**STATE OF TENNESSEE  
DEPARTMENT OF TRANSPORTATION**

**RE: Concept Approval Letter  
Highway Entrance and Work on State ROW  
State Route 34  
Parcel No: 008I F 004.02**

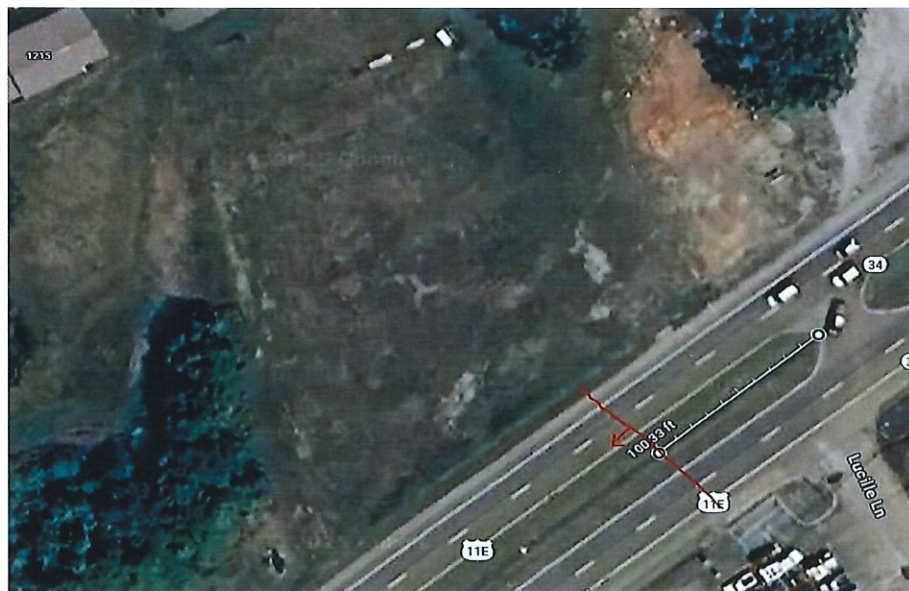
Any new access points to the property must be at least 100FT away from the existing median opening at Lucille Ln (as roughly shown in aerial). Other field entrances that are currently in place would need to be removed as part of commercial entrance permitting.
